TESLA SUPERCHARGER STATION
3310 S MERIDIAN ST. (TESLA SUPERCHARGER)
PUYALLUP, WA 98373

C-111

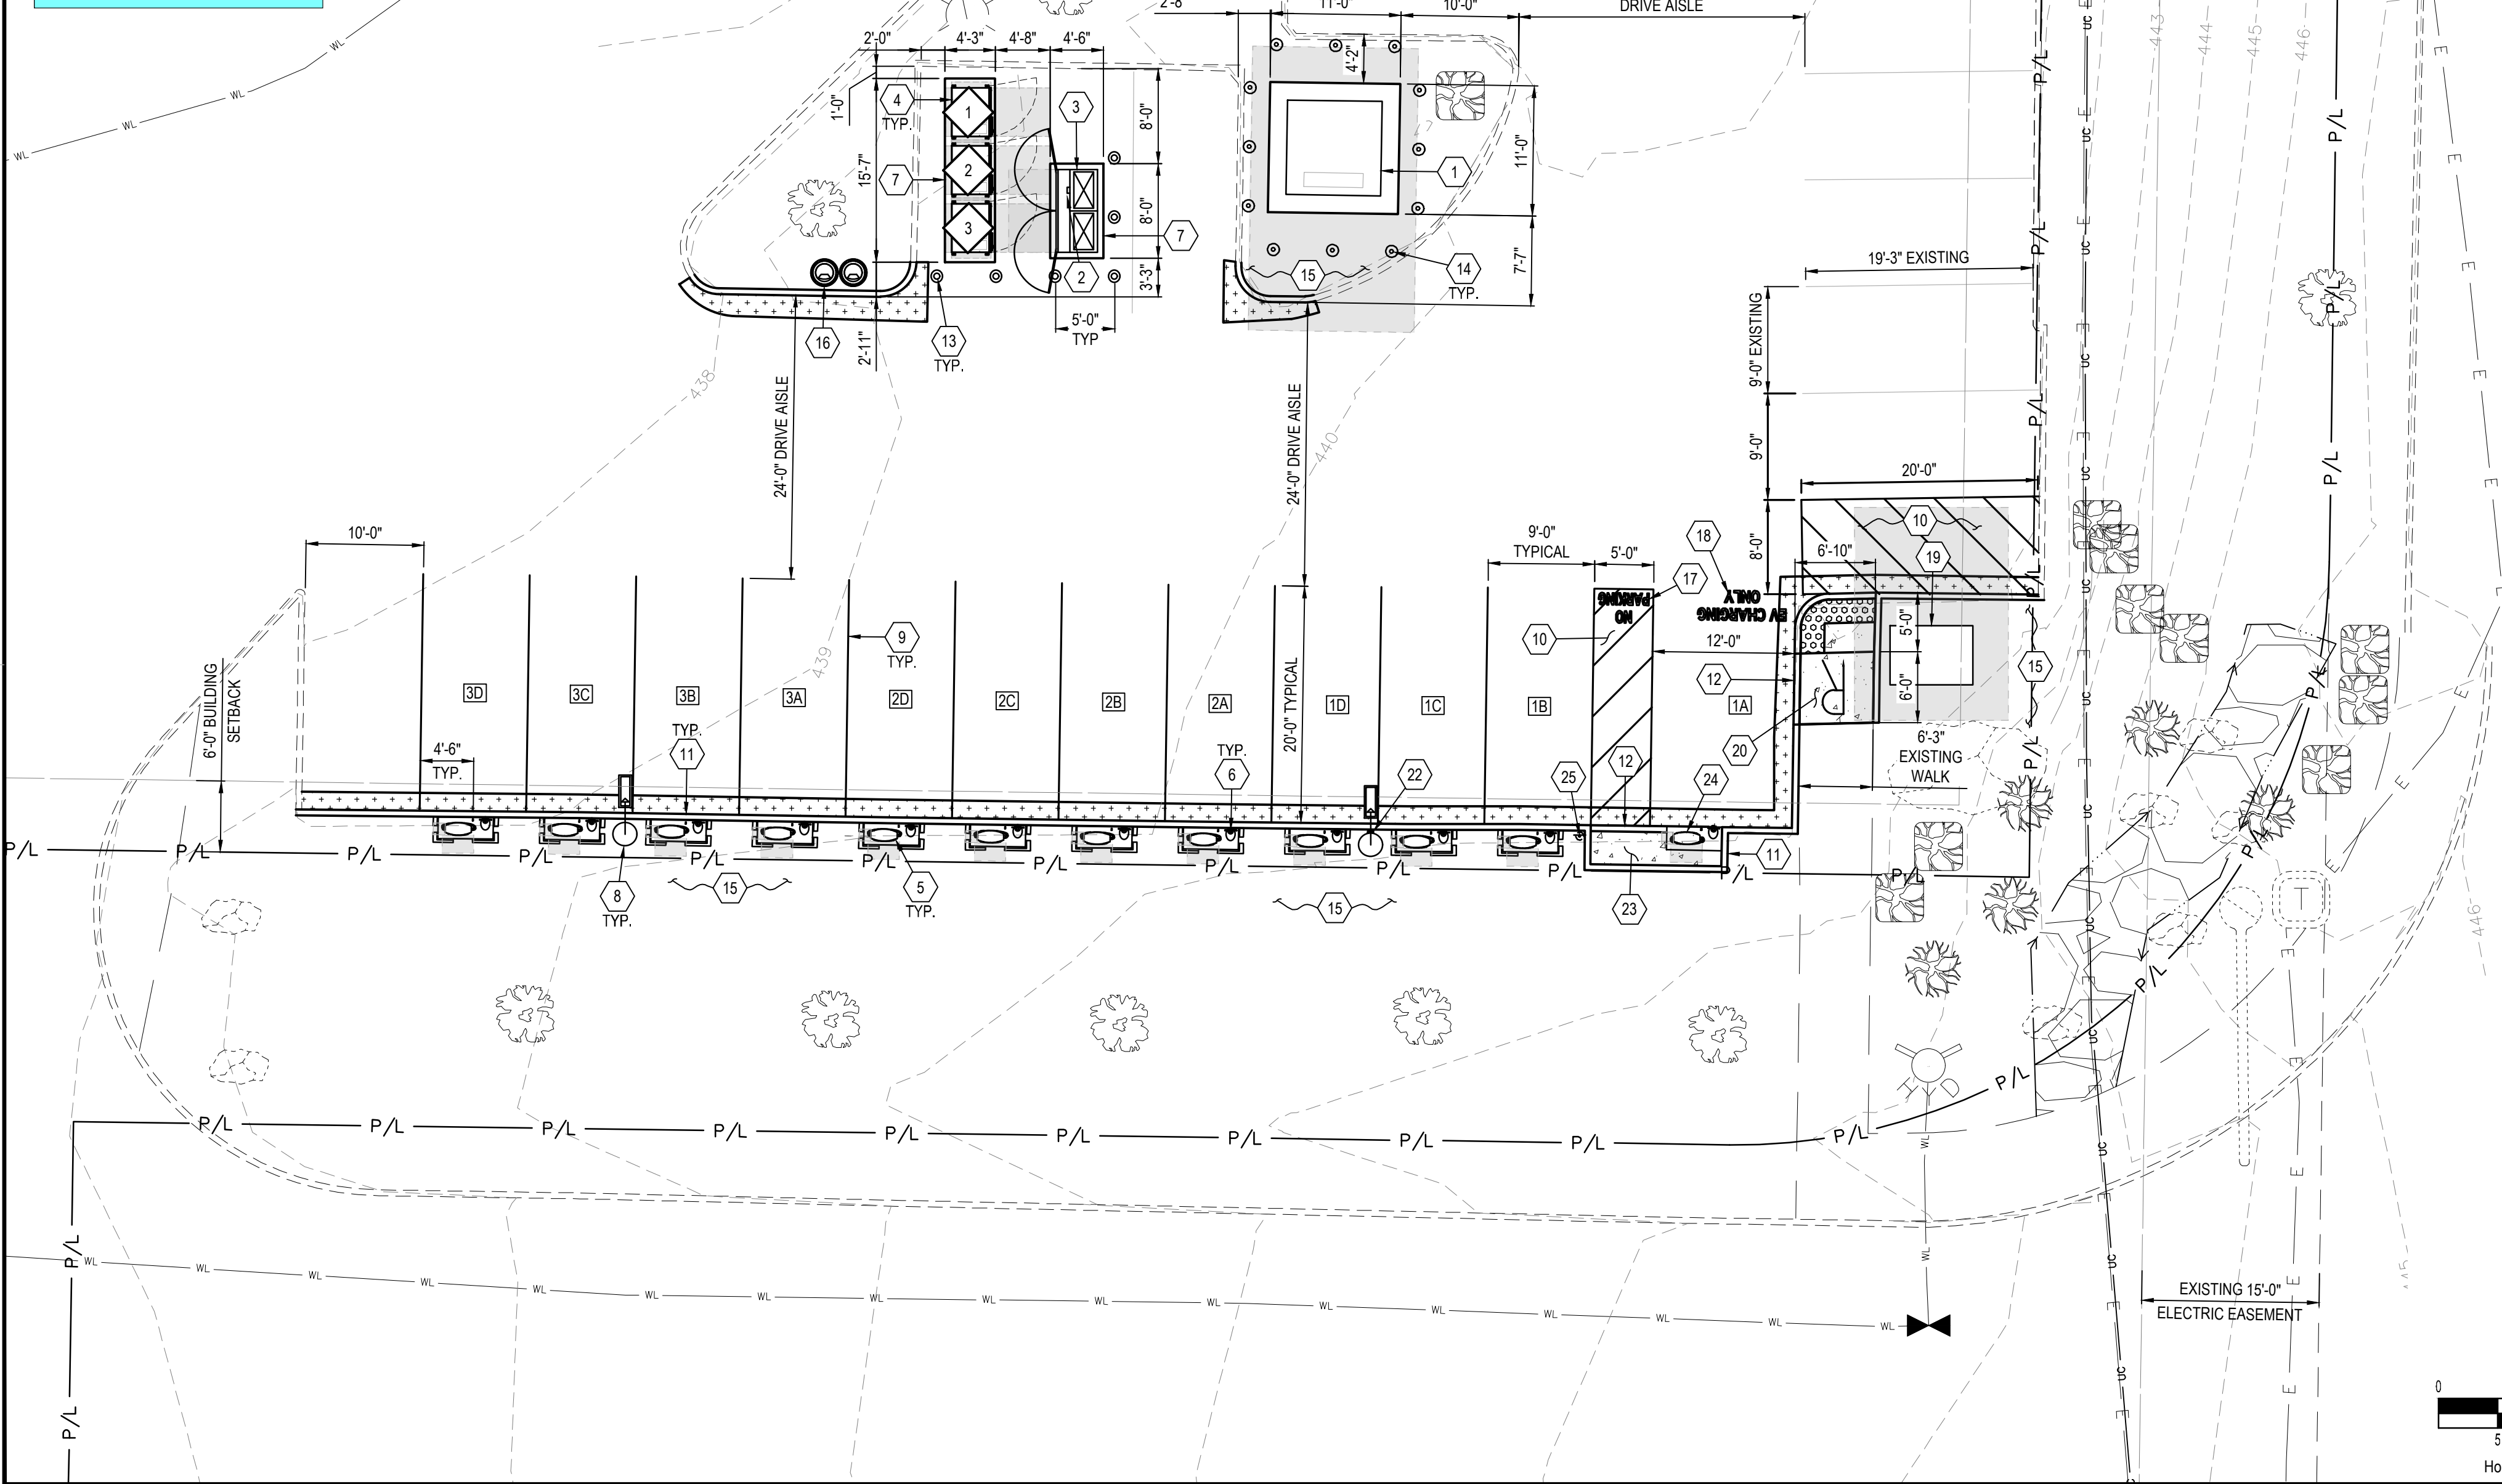
The need to verify that there will be no impact to Fruitland Mutual Water Co is required. The proposed charging stations and or equipment cannot be placed over or near their water mains [Site Plan Sheet 1 of 1]

The applicant shall request a sediment control and erosion inspection with a City Engineering Inspector through the CityView portal at least 48 hours in advance of job start. See City Standards 02.03.02 & 05.02.01

Sediment control and erosion procedures shall be practiced eliminating and preventing off site damage. Stormwater runoff originating upgrade of exposed areas shall be controlled to reduce erosion and sediment loss during the period of exposure. Refer to the Stormwater Fact Sheet and City standard details 02.03.02 & 05.02.01 for typical erosion and sedimentation control methods. Attached in CityView
